# Groundwater Application Review Summary Form

Application # G- 18749

GW Reviewer Travis Brown Date Review Completed: 4/1/2019

TO: Water Rights Section Date 4/1/2019  
 FROM: Groundwater Section Travis Brown  
 Reviewer's Name  
 SUBJECT: Application G- 18749 Supersedes review of \_\_\_\_\_  
 Date of Review(s)

Well Location Map

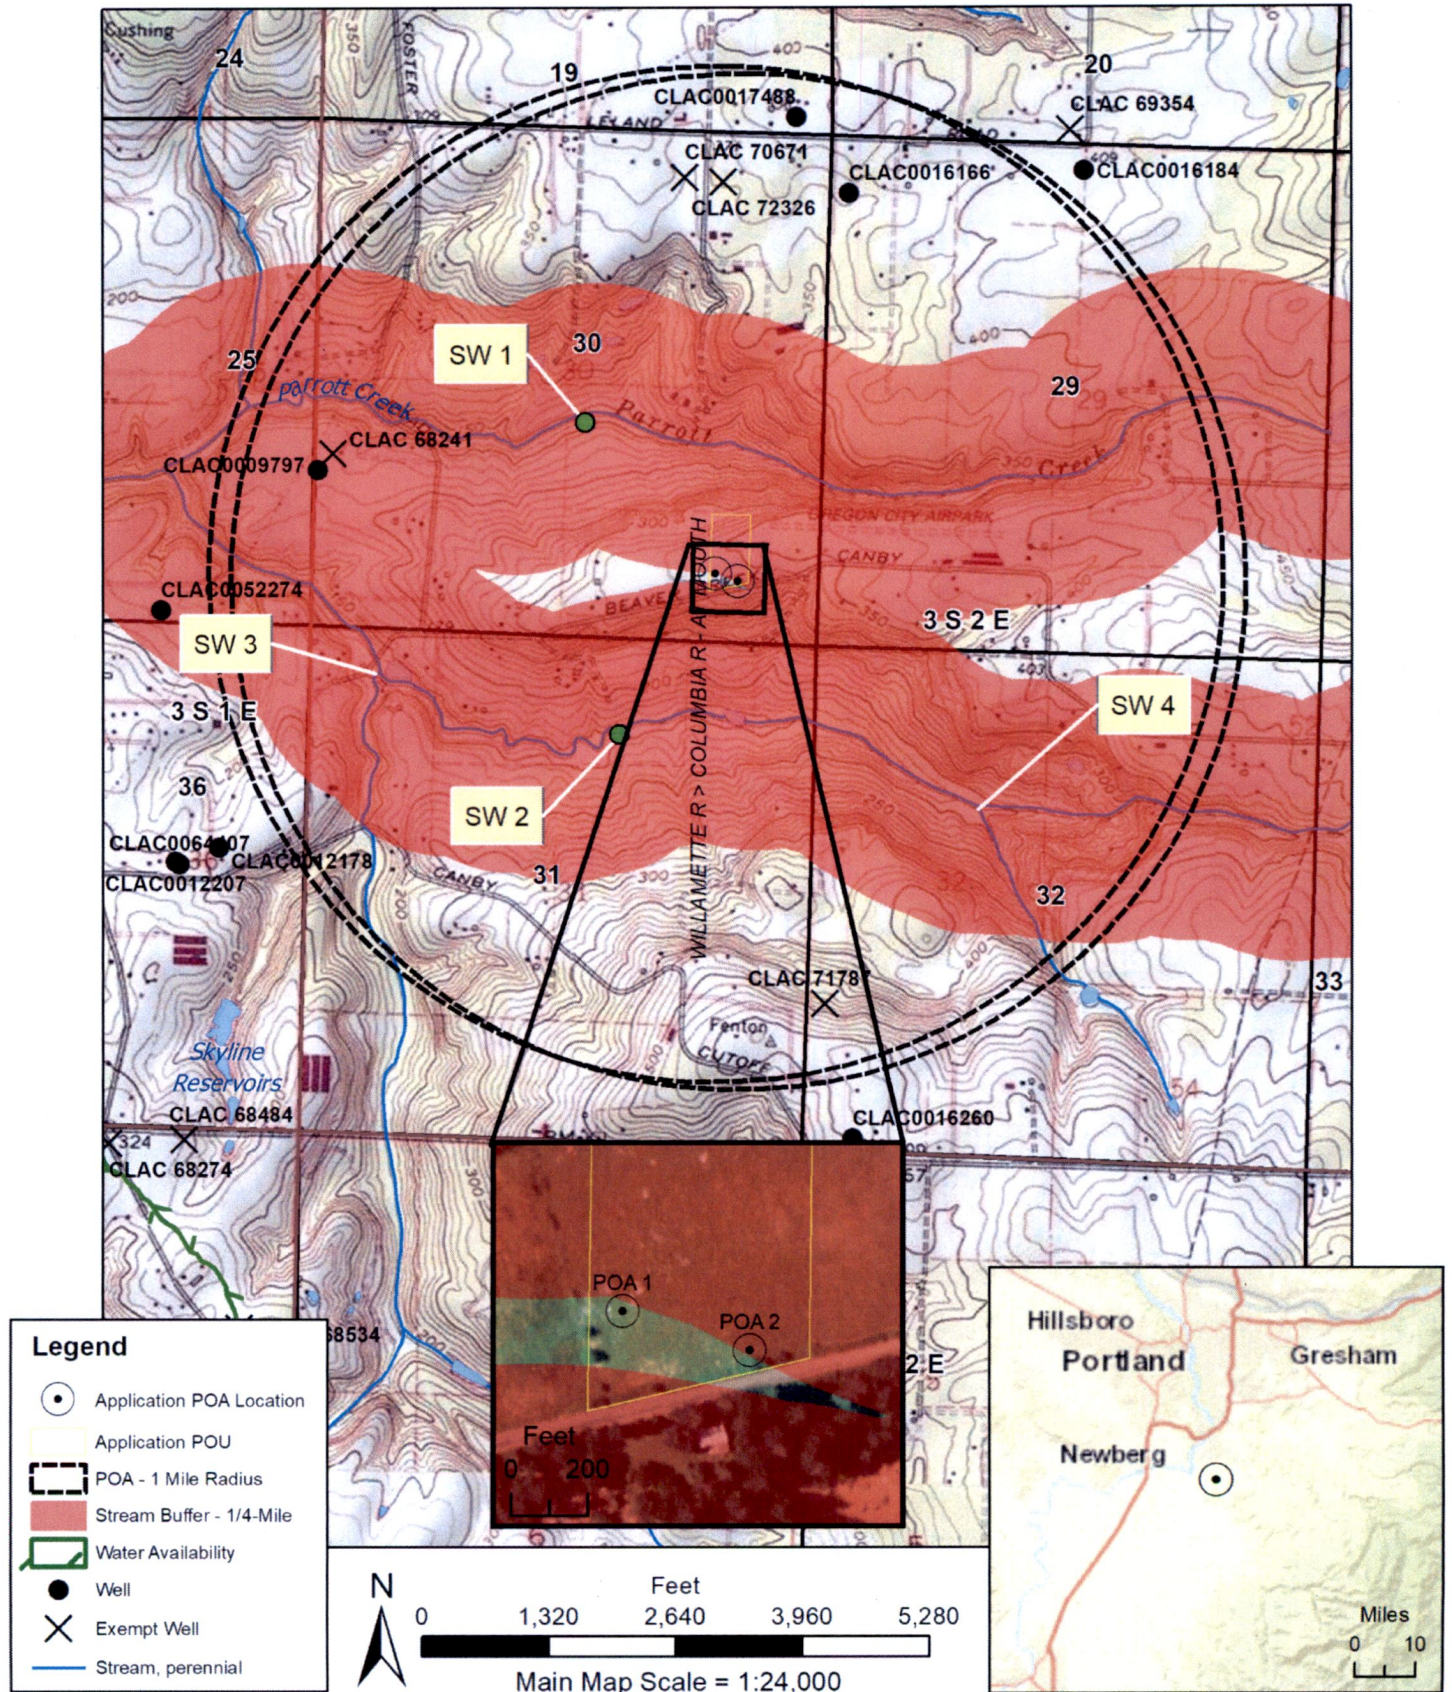
**Comments:** The proposed POA 2 location appears to be just within ¼ mile of the nearest surface water source, SW 1 (see Well Location Map). On this basis, the Potential for Substantial Interference (PSI) is assumed per OAR 690-009-0040(4)(a). However, this is the only basis for assuming PSI for the proposed POA. Should the applicant revise the location of their proposed POA so that it would be greater than 1,320 ft from the nearest surface water source, a new groundwater review should not be required.

- C5.  **If properly conditioned**, the surface water source(s) can be adequately protected from interference, and/or groundwater use under this permit can be regulated if it is found to substantially interfere with surface water:
- i.  The permit should contain condition #(s) \_\_\_\_\_;
  - ii.  The permit should contain special condition(s) as indicated in "Remarks" below;
- C6. **SW / GW Remarks and Conditions:** C3a: **The proposed POA 2 appears to be within ¼-mile of SW 1 (Parrott Creek); PSI is assumed on this basis alone. The applicant may revise the proposed POA 2 location to avoid triggering PSI on this basis without the need for a new groundwater review.**

### Hydrographs

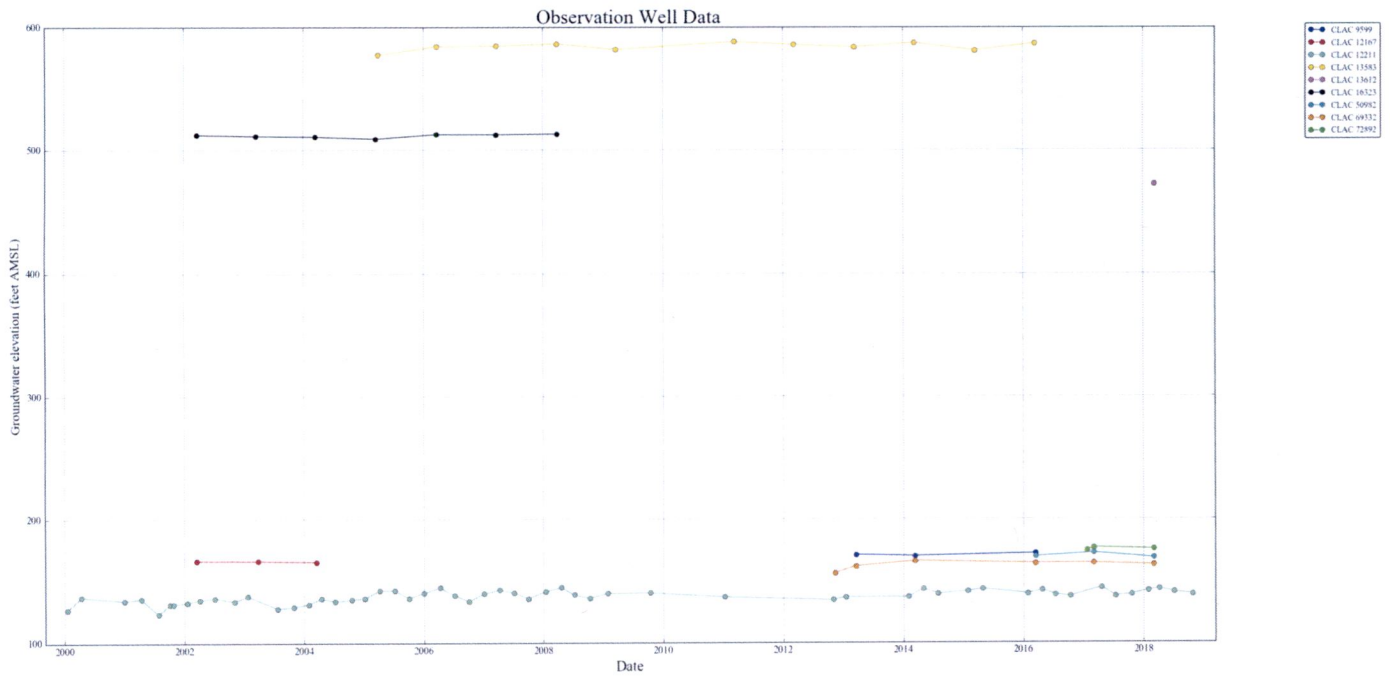
Water level data is sparse around the proposed POA. The nearest observation wells with potentially applicable data are greater than 1.8 miles away from the proposed POA. Reported water levels in these observation wells do not show widespread or consistent declines (see Hydrographs, attached).

### Well Statistics – Adjacent Quarter-Sections

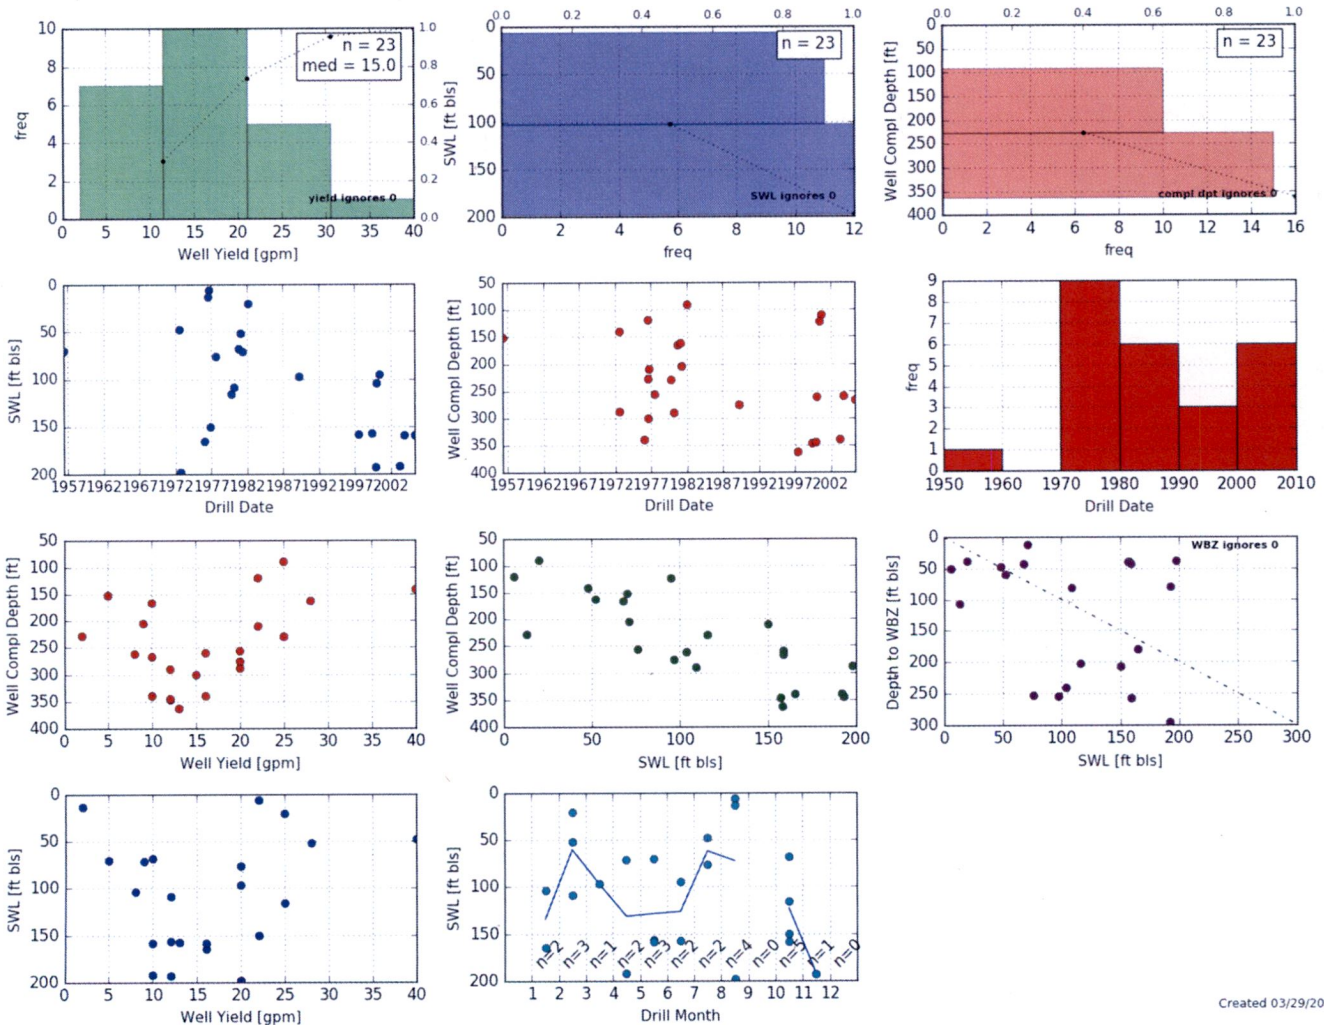
Twenty-three (23) water wells with reported yields were identified in the same or adjacent quarter-sections as the proposed POA. Completed depths for these wells ranged from 90 to 363 ft bls. Reported yields ranged from 2 to 40 gpm, with a median yield of 15 gpm (see Well Statistics – Adjacent Quarter Sections, attached). There appears to be a modest trend of decreasing yield with depth. Assuming that the requested maximum rate (91 gpm / ~0.2028 cfs) would be evenly distributed between the two proposed POA (i.e. yield of 45.5 gpm / ~0.1014 cfs per well), the requested rate would be ~114 percent of the maximum reported yield and ~303 percent of the median yield from nearby wells. **Based on the nearby well statistics, it is unlikely that the applicant will be able to obtain the requested maximum rate (91 gpm / ~0.2028 cfs) from the two proposed POA. However, due to the lack of current, applicable information, it cannot be stated whether the proposed**

**use will or will not be available in the amounts requested without injury to prior water rights or within the capacity of the groundwater resource.**
